Report to Committee

Re: Application by FNDA Architecture Inc. for Rezoning at 9560, 9580 Cambie Road and 9531, 9551, 9571 Odlin Road from Single-Family Housing District, Subdivision Area F (R1/F) to Assembly District (ASY)

**EXCERPT FROM THE MINUTES FROM
THE DESIGN PANEL MEETING**

Re: Advisory Design Panel and Staff Comments, April 1, 2009
9560/9580 Cambie and 9531/9551/9571 Odlin Road

Signage Detail

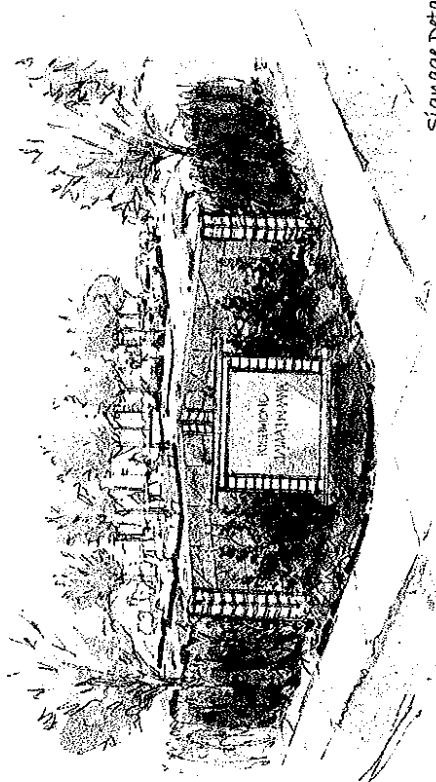
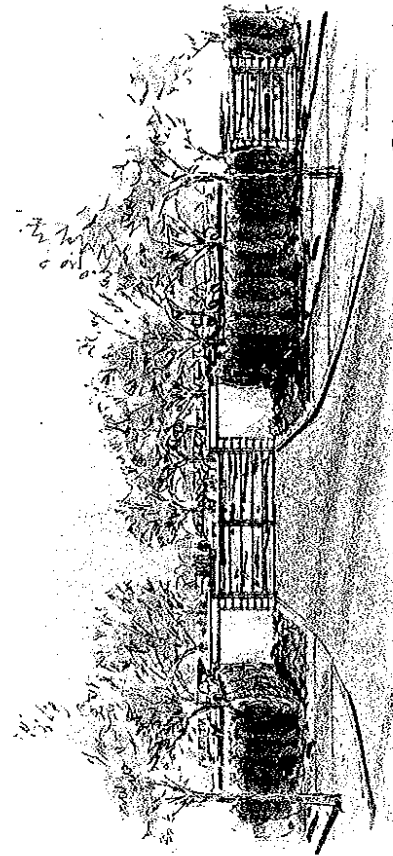
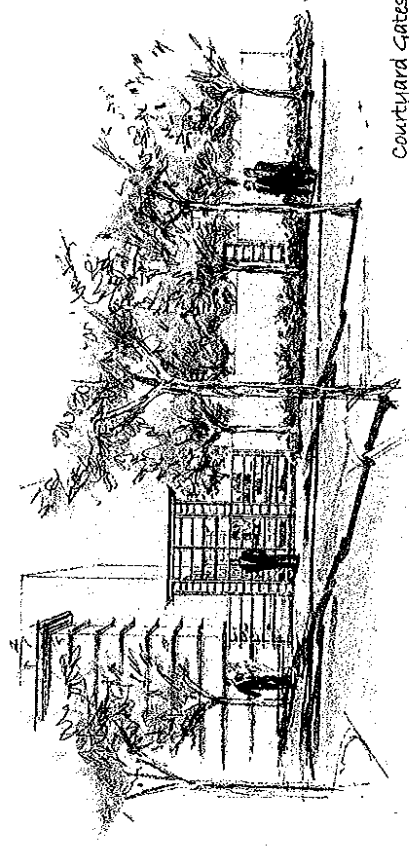
- 1 explore the possibility of integrating artful elements in gates and signage at the perimeter of the site;

We will be accommodating this request during Design Development stage. Gates will be of moderate proportion, and will be mostly transparent.

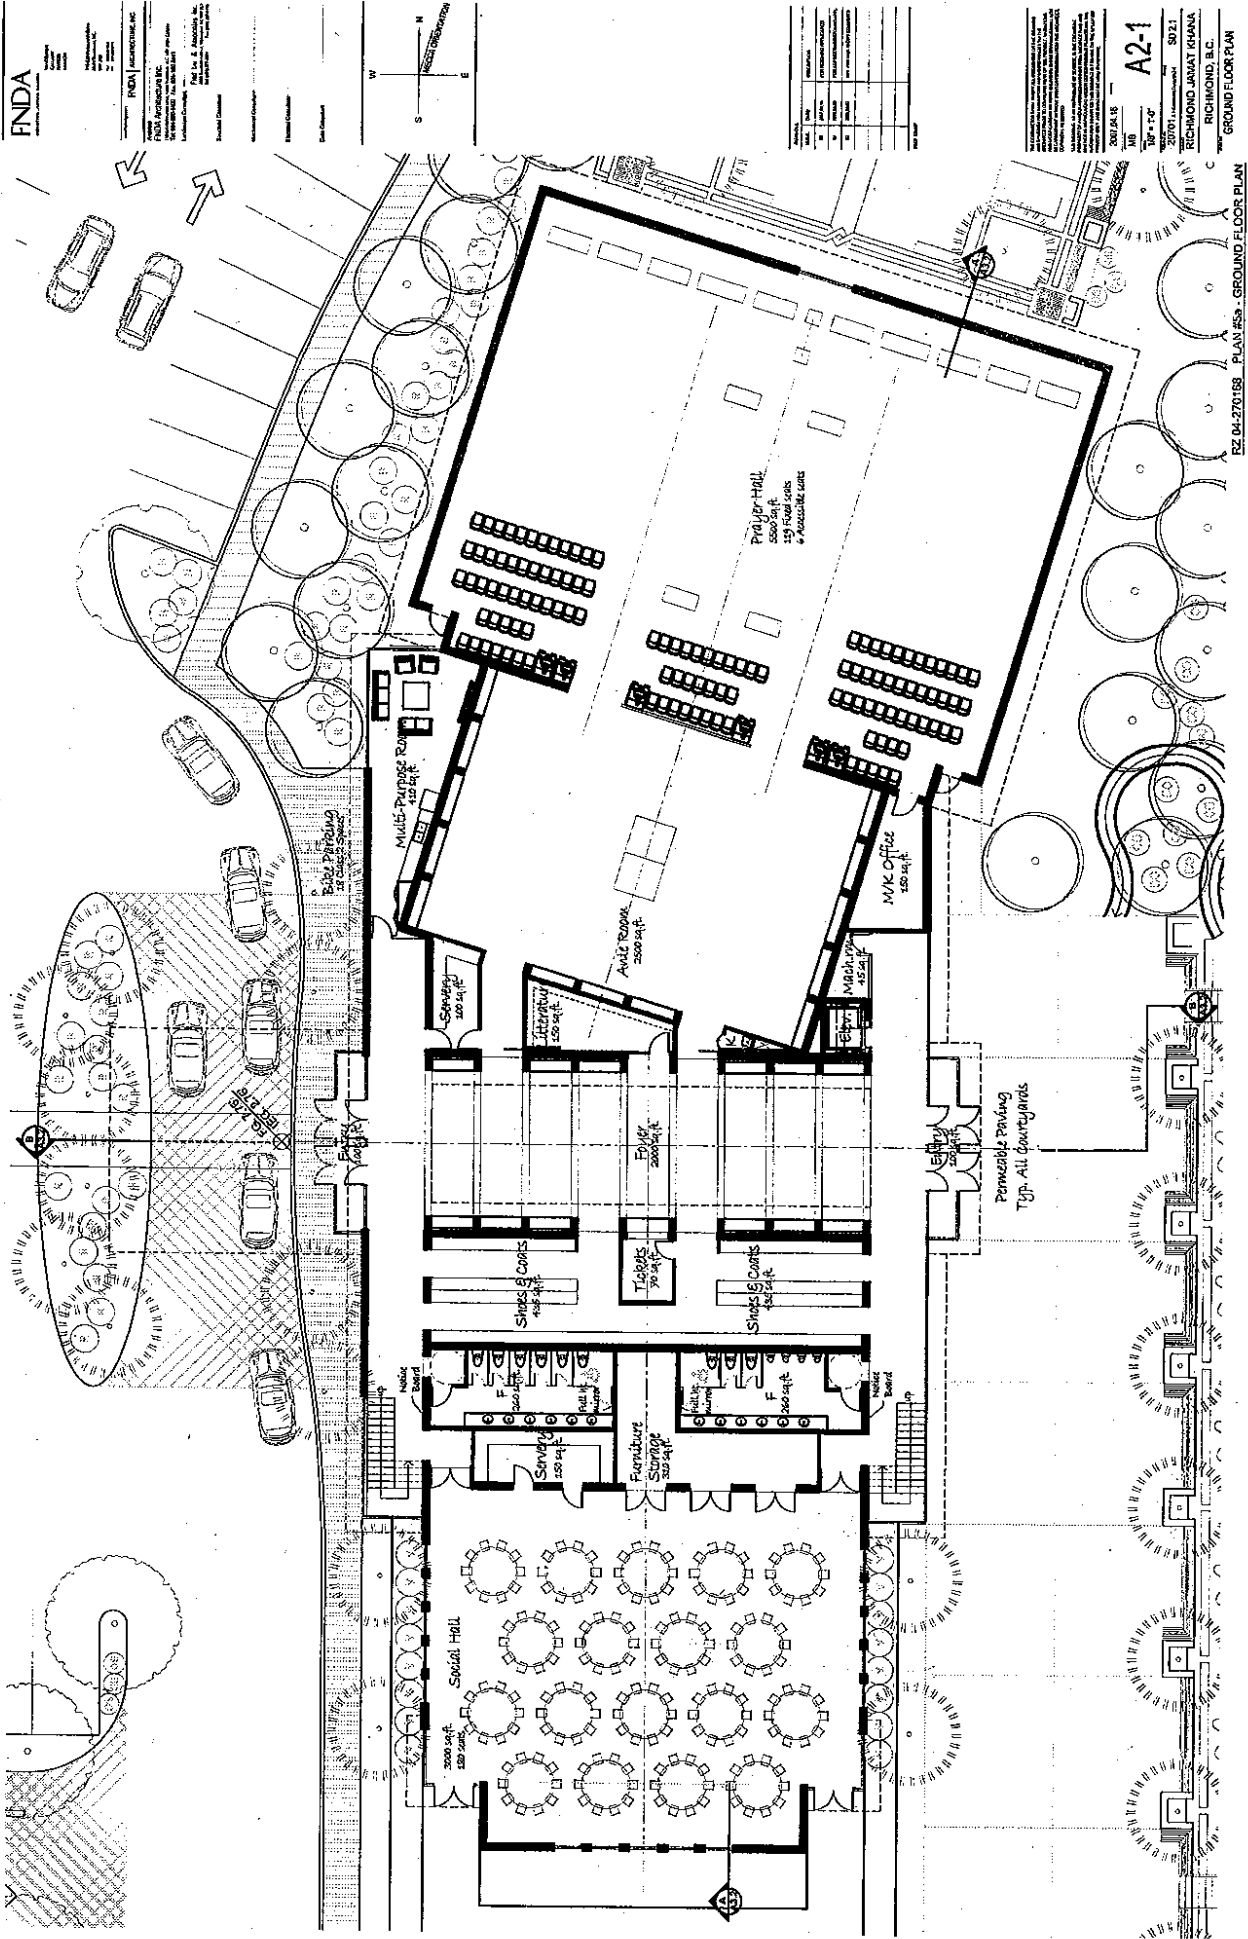
- 2 consider the design of the prayer hall to break up the aisle in order integrate disabled seating with general seating;

We have revised our floor plan accordingly, please refer to 'Plan 5a - Main Floor'.
